7314 45th Ave S

PROJECT DATA

RESPONSE TO EDG:

Side View From 45th Ave S.

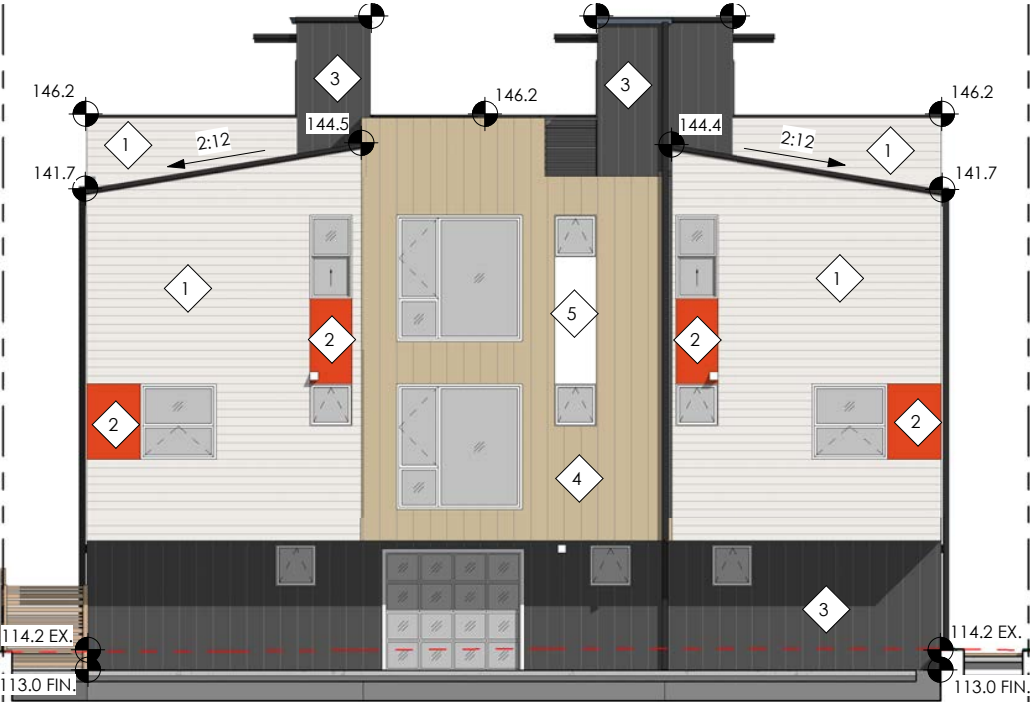
As rendered, the interior pathway to Units 3-6 illustrates a tall and narrow canyon formed above the boardwalk. Incorporate modulation, setbacks, or other massing sifs on the facades that abut the interior pathway, to reduce their perceived mass and create a welcoming atmosphere.

Primarily, units 1-3 and 4-7 all propose shed roofs to lower the percieved height along the north and south property lines and facades to bring the massing closer to pedestrian scale and better relate to the adjacent properties. In addition, entry modulation is proposed at units 3-7 to help with wayfinding along the south boardwalk and to make the approach more welcoming for the tenant. Wood siding is also proposed as a warmer material at all entries to assist in wayfinding and create a more-welcoming experience.

Additional modulations were added at the second level above the parking area, accentuated by a change in material below. The white lap siding is scaled-down to 4" for a more appropriate proportion to human-scale and red hardi-panel banding at windows help to break down the larger lap siding areas and to decrease the canyon-wall effect.

Site Plan

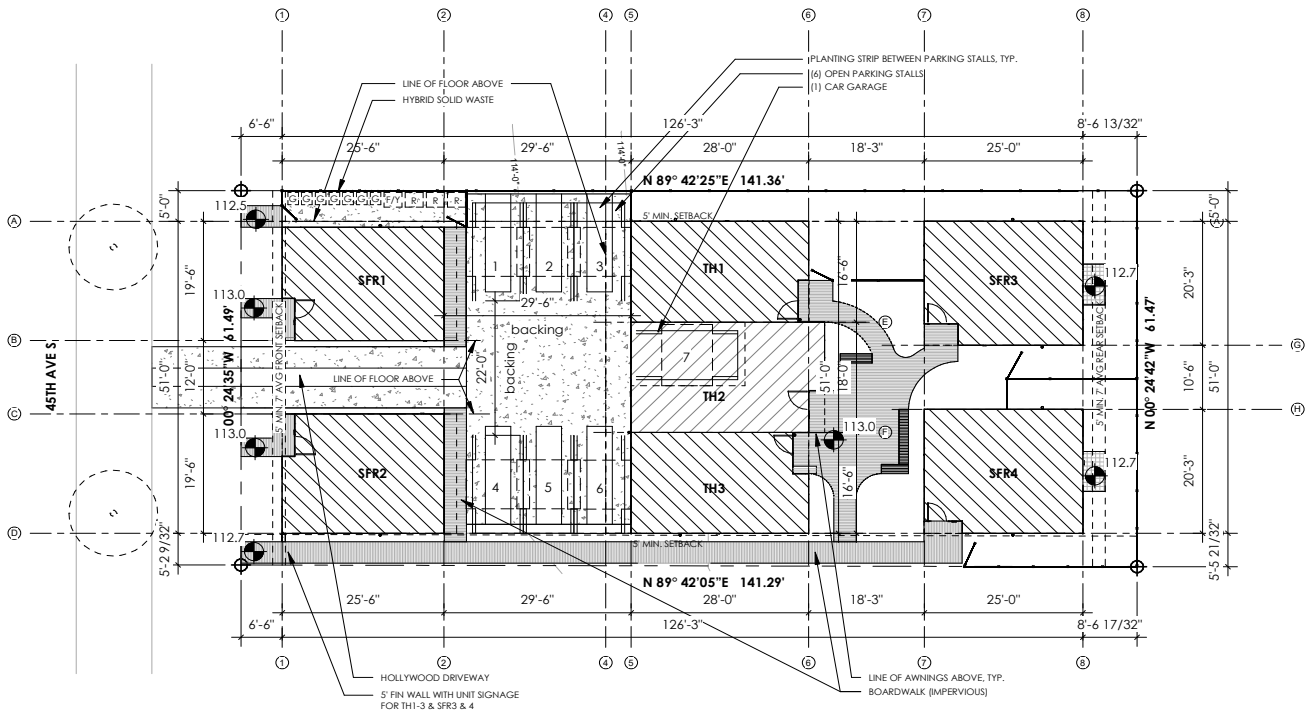
GUIDANCE:	RESPONSE:	DESIGN GUIDELINES
3. Parking Access, Site Circulation, and Wayfinding: Reduce the visual width of the driveway. Consider an overhead trellis, gateway, or other design features that create an inviting and appropriately scaled entry to the site.	Visual width of the driveway is reduced with the use of the hollywood driveway, as well as, through the use of 4" white lap siding and red hardi-panel banding, both of which break down the scale of the walls facing the driveway. The modulations at Units 1 & 2 entries and at the first level of Units 1-5 accompanied by a change in material both provide relief from the overall scale and visual-access cues for entry and parking spaces. Additionally, a change in material at the penthouses reduces the overall height.	DC1-B-1-b, DC1-C-2, DC2-D-1
Consider adding secondary entries that face the parking area, for those adjacent units that abut it (1, 2, 3, and 5).	This approach was considered. In response, units 3-7 were shifted 3'-6" east to accommodate a path from the solid waste enclosure and parking area to the south entry access route. This reduces the entry path length to units 3-5 and provides a more direct connection to the solid waste storage. A separation between pedestrian and vehicular circulation is preferred for safety and cleanliness, and to keep a more inviting entry approach through the shared courtyard space.	PL4-A-2, DC3-A-1

The solid waste access is disconnected from rest of site. Consider revising the circulation to provide more direct access, which maintaining an attractive edge through screening, plantings, or other design treatment.	Units 3-7 were shifted 3'-6" east to accommodate a path from the solid waste enclosure and parking area to the south entry access route.	DC1-C-4
Incorporate signage or architectural features into the design of the pathways to aid wayfinding and identify sign locations on the land use plan set.	Signage was added at the SW boardwalk entry of units 3-7 to assist in wayfinding along the south entry approach path. Unit signage is also proposed at each entry recess. The entry gate and fence was omitted along this corner and property line to create a more inviting approach to the common amenity area.	PL2-D-1

Site Plan

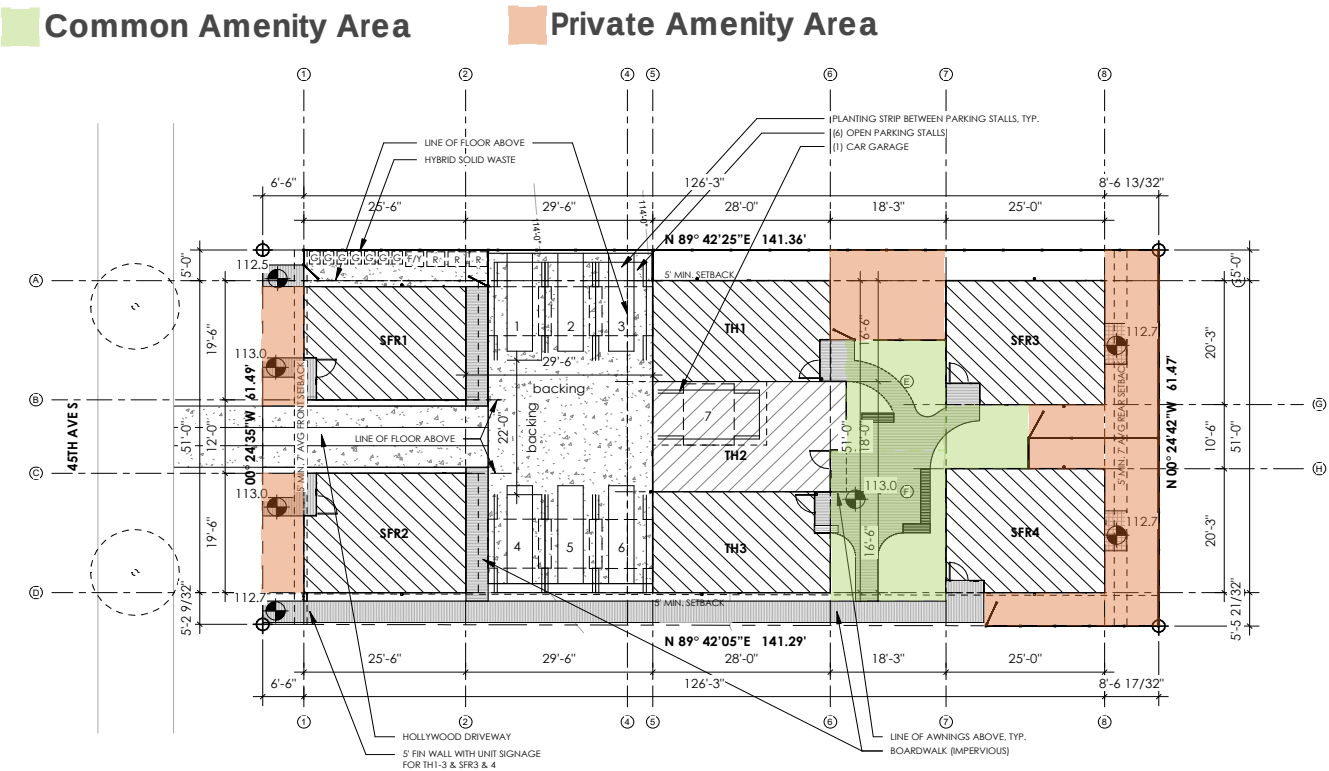
Develop an open space concept that encourages use and social interaction. A combination of hardscaping, weather protection, landscaping, seating, and other features can be used to create inviting and practical outdoor areas for residents, for use by all; dividing the open space with fences is discouraged.

Consider designing the front setback area to respond to the park across the street, so that residents may use this area to enjoy the view and activities.

Over time we have conducted dozens of post-occupancy surveys from occupants living in multifamily homes that we designed. Fences are strongly preferred for tenants for a sense of safety and for tenants with dogs. We propose a mix between common and private amenity space and struck a balance between the two and accommodate both gathering as well as private use.

Within the courtyard shared between units 3-7, we designed a central-gathering boardwalk area with built-in benches as an extension of the walkway and to encourage an inviting and practical space for residents to enjoy. In addition, the surrounding landscape was designed to encourage use of a dry river play area between units with climbing rocks and basalt dishes. The formalized central boardwalk seating space was designed for more casual enjoyment and gardening opportunities.

The central common amenity area expanded east slightly to accommodate more shared landscaping opportunities.

Units 1 & 2 were shifted 6" east to maximize yard space and enhance the connection to Othello Playground and the adjacent sidewalk. The entry paths to Units 1 & 2 were also located to minimize private space and maximize open landscaping as an extension of the Playground.
